MIL-N-60189(MU)
AMENDMENT 3
9 June 1967
SUPERSEDING
AMENDMENT 2
18 April 1967

MILITARY SPECIFICATION

NETWORK D CIRCUIT BOARD: 8623286

This amendment forms a part of Military Specification MIL-N-60189(MU), dated 23 February 1965.

FIGURE 2

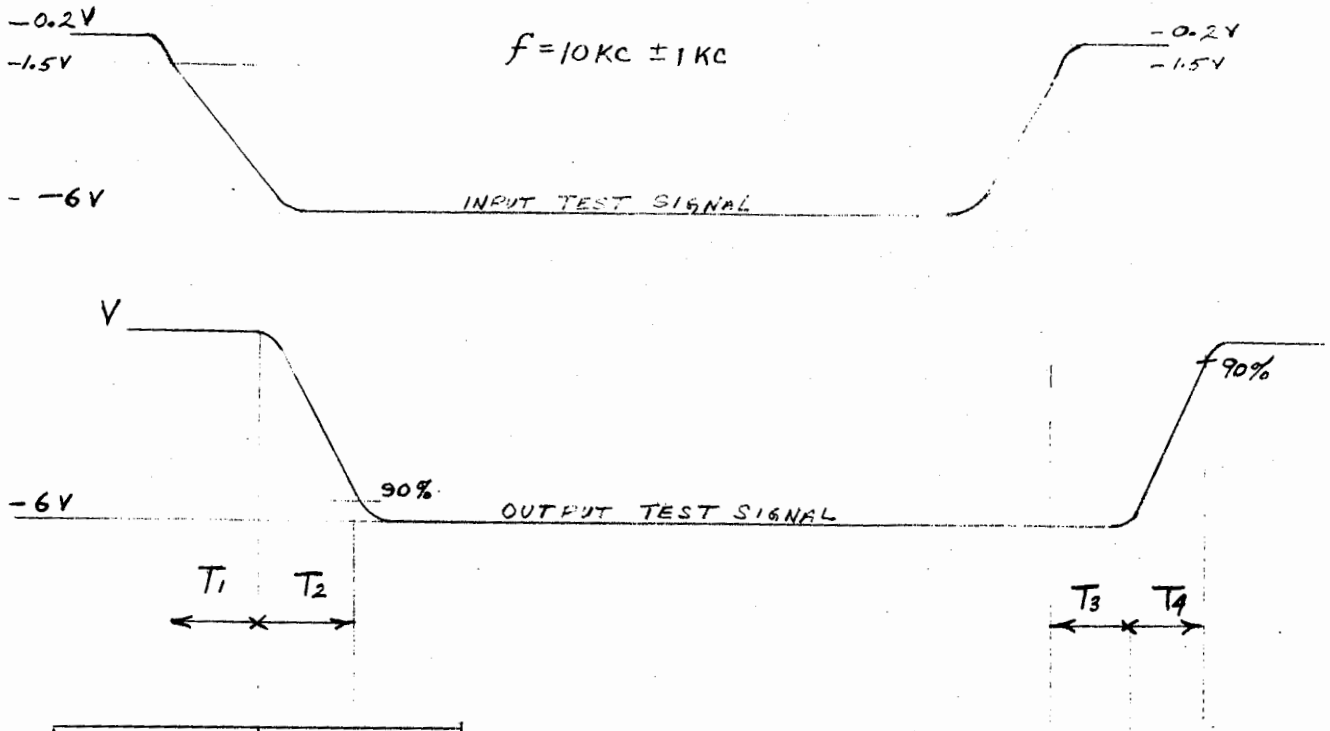
Figure 2: Delete and substitute new Figure 2 shown on Page 2 of this amendment.

CIRCUIT	OUTPUT - VOLTS				
DUR. DLR.	+3 ± 0.12	T_1+T_2 < 400 NANO SEC.		T_3+T_4 < 400 NANO SEC.	
REGULAR	-0.15 ± 0.15	T_1+T_2 < 400 NANO SEC.		T_3+T_4 < 400 NANO SEC.	
		T_1	T_2	T_3	T_4
CLOCK	+6 ± 1.0	< 3μ SEC.	< 1μ SEC.	< 3μ SEC.	< 500 NANO. SEC
CLOCK INHIBIT	+3 ± 0.12	< 5μ SEC.	< 1.5μ SEC.	< 9μ SEC.	< 1.5 μ SEC.

Delay time comparison of input and output waveforms. The delay time (T_1 and T_2) from the time the square wave applied to the input gate reaches minus 1.5 volts (going towards minus 6 volts) until the output reaches 90% of its total excursion (going towards minus 6 volts) and delay time (T_3 and T_4) measured from the time the square wave applied to the input gate reaches minus 1.5 volts (going towards zero volts) until the output reaches 90% of its total excursion (going towards the false state plus 3 volts) shall be as indicated in the table. The delay time (T_1) is measured from the time the square wave is applied to the input gate reaches minus 1.5V (going toward -6V) until output just starts descending and the delay time T_3 is measured from the time the square wave applied reaches -1.5V (going toward zero volts) until the output just starts rising. For extreme temperatures add 5% to the limits of $T_1 + T_2$ and $T_3 + T_4$.
